**Before the  
New York Public Service Commission**

Proceeding on Motion of the Commission as to )  
the Rates, Charges, Rules and Regulations of ) Case 20-E-0380  
Niagara Mohawk Power Corporation d/b/a )  
National Grid for Electric Service. )

**DIRECT TESTIMONY OF  
ALICE NAPOLEON  
AND  
KENJI TAKAHASHI

ON BEHALF OF  
NATURAL RESOURCES DEFENSE COUNCIL  
AND  
THE SIERRA CLUB**

3 **Figure 4. Building Gas Demand Reduction Needed to Meet CLCPA under E3 Study**

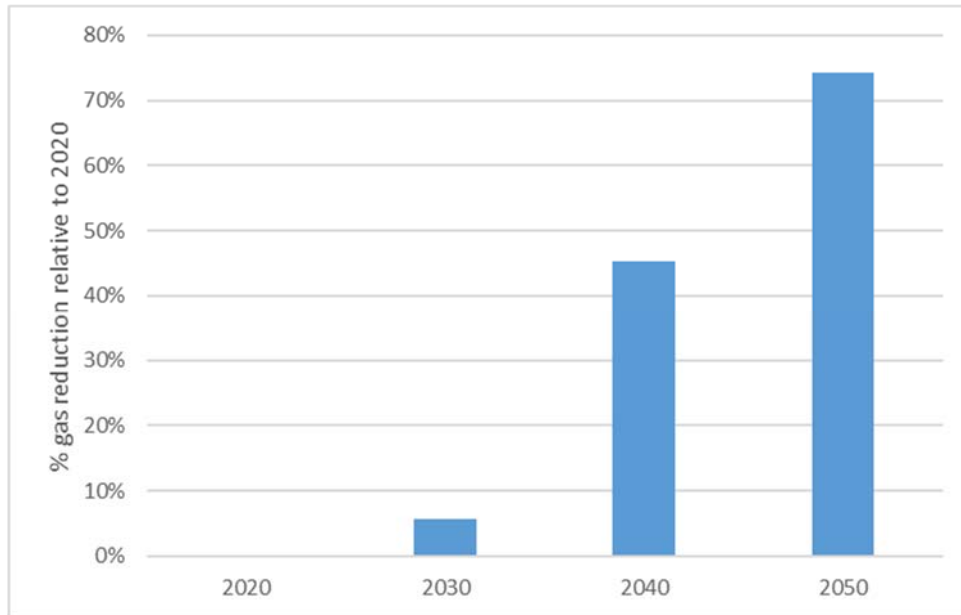
18       A.     According to E3’s 2020 paper, *Pathways to Deep Decarbonization in New York State*,  
19               prepared for NYSERDA, the state of New York needs to reduce gas consumption in the

1 building sector by 45 percent by 2040 and 75 percent by 2050 relative to today's level in  
2 one of the scenarios analyzed in the study. This is shown in Figure 4 below.

5 A. We recommend that the Company examine its energy efficiency offerings and eliminate  
6 rebates for long-lived gas consuming equipment. Instead, it should focus on gas  
7 weatherization measures (e.g., insulation, air sealing, tank and pipe wraps) as well as  
8 other gas reduction measures such as aerators, low-flow shower heads and heating and  
9 energy recovery ventilators. Further, in areas where NiMo only provides gas service, the  
10 Company should actively coordinate with overlapping electric utilities and provide  
11 customers with information about incentives and technical support from those entities on  
12 heat pumps.
